BULLETIN NUMBER: SB12-K-002

#### AISIN TRANSMISSION BREATHER HOSE RESTRICTION - UPDATED VENT

- 2007-2012MY Isuzu N-Series
- 2007-2010MY Chevrolet/GMC W-Series

Equipped with AISIN A460/A465 Automatic Transmission

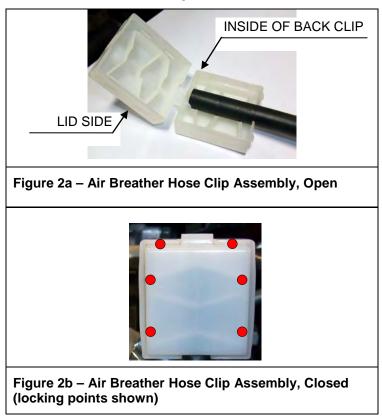
- 2. Install the trans vent hose into the air breather hose clip.
  - a. The hose must be placed into the top of the guide so the end touches the wall.
  - b. The clip should be closed by locking the six latches.

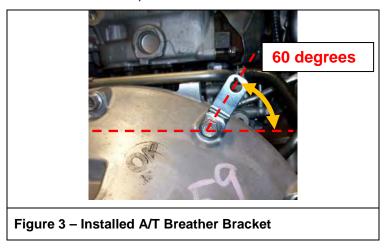
IMPORTANT: Be sure to set the hose on the inside back of the clip, as shown in Figure 2a. If improperly set on the lid side, it will allow the hose to move and become pinched.
